Applicant:	HOM Furniture (Owner and User) Budget Truck Rental, LLC (Owner)
Locations:	7800 and 7850 Dupont Avenue South and 1217 Clover Drive
Request:	<ol style="list-style-type: none"><li>1) Rezoning 1217 Clover Drive from I-3 to C-3(PD)</li><li>2) Type II Preliminary and Final Plat to combine three lots into one lot</li><li>3) Preliminary and Final Development Plans for the renovation and expansion of an existing furniture store</li></ol>
Existing Land Use and Zoning:	Furniture store and truck rental facility; zoned C-3(PD) Freeway Commercial Center (Planned Development) and I-3 General Industrial
Surrounding Land Use and Zoning:	North – Interstate Highway 494 South – Place of assembly; zoned I-3 East – Motor vehicle sales (Class I); zoned I-3 West – Motor vehicle sales (Class I) and Interstate Highway 35W; zoned CR-1(PD)
Comprehensive Plan Designation:	Regional Commercial

## PROPOSAL

**Project Description:** Rezoning from I-3 to C-3(PD) for 1217 Clover Drive, Type II Preliminary and Final Plat, Preliminary and Final Development Plans for the renovation and expansion of a furniture store.

**Address:** 7800 and 7850 Dupont Avenue South and 1217 Clover Drive

**Figure 1 – Rezoning 1217 Clover Drive form I-3 to C-3(PD)**

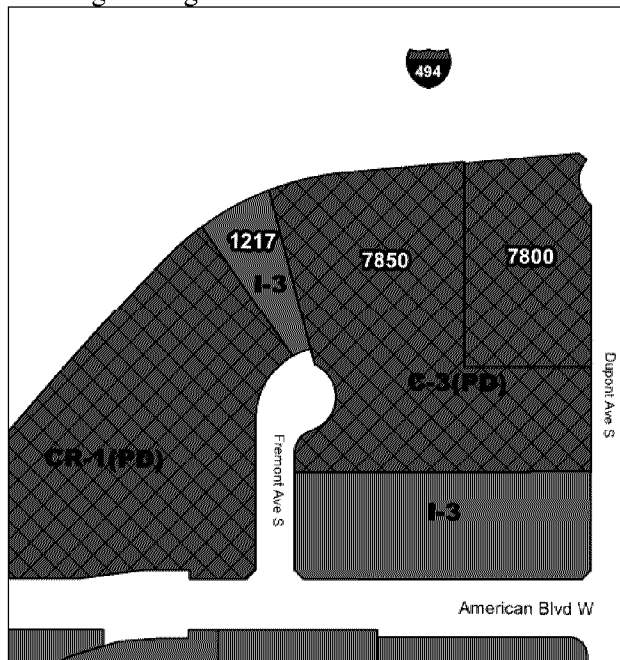
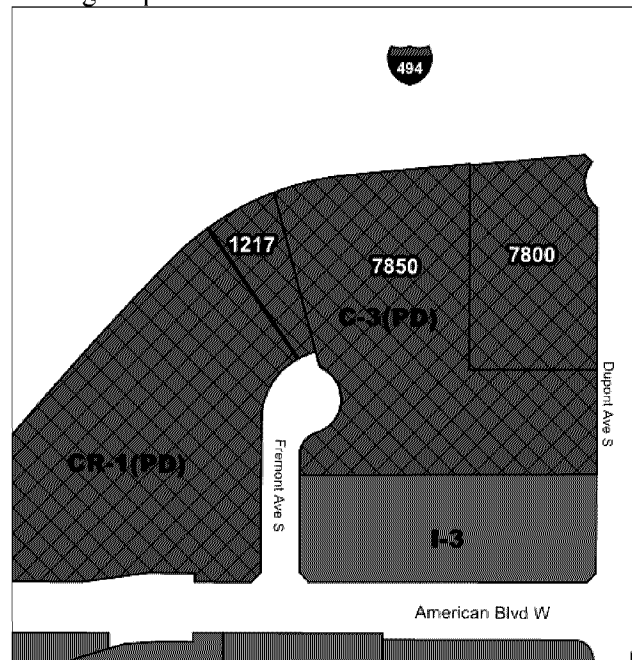
The existing zoning of 1217 Clover Drive, I-3 General Industrial, is not consistent with the Regional Commercial guidance. Retail sales and services is not a permitted use in the I-3 zoning district. Rezoning 1217 Clover Drive from I-3 to C-3 brings the site into harmony with the City's Comprehensive Plan. The addition of the Planned Development (PD) Overlay District relates to the Preliminary and Final Development Plans submitted by the applicant. If the subject Final Development Plans are approved, the PD Overlay must be extended over 1217 Clover Drive.

**Figure 2 – Front Setback Southwest Corner**

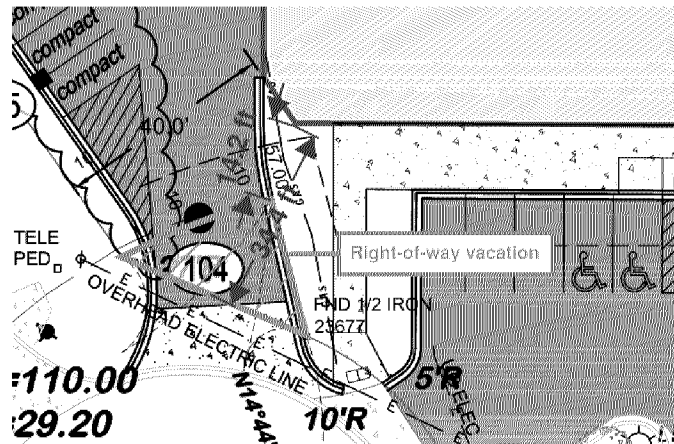
Extending the western portion of the building southward would result in a 14.2-foot setback from the property line along Fremont Avenue. City Code requires a 35-foot front setback in the C-5 zoning district. The applicants are requesting a deviation through the PD Overlay District for a reduced front setback. The reduced setback can be reviewed in Figure 2. Staff is supportive of the reduced front setback to Fremont Circle for two reasons:

- 1) **Right of Way Vacation** – The right-of-way for the Fremont Avenue cul-de-sac has an odd configuration due to a previous connection from Fremont Ave to Dupont Avenue envisioned through the HOM Furniture property that was never constructed. A public road connection through the HOM property will not be constructed in the future. Through the request of a street right-of-way vacation, the front property line can be moved south, increasing the front setback from 14.2 feet to approximately 34 feet. Following the street right-of-way vacation, the setback would nearly be compliant to the C-3 requirement. HOM Furniture has formally

- 2) **Potential 494-35W Interchange Impacts** – Shifting the western portion of the building slightly southward is beneficial in that it would move the structure further away from public right-of-way that may be needed to construct future interchange ramps. In staff's judgment, this circumstance warrants consideration of a reduced setback through PD flexibility.

Staff is supportive of a deviation to reduce the front setback to Fremont Avenue South from 35 to 14.2 feet from the existing property line. As noted above and shown in Figure 2, once the right-of-way vacation occurs, the setback will likely increase to approximately 34 feet, representing a condition that would be nearly compliant.
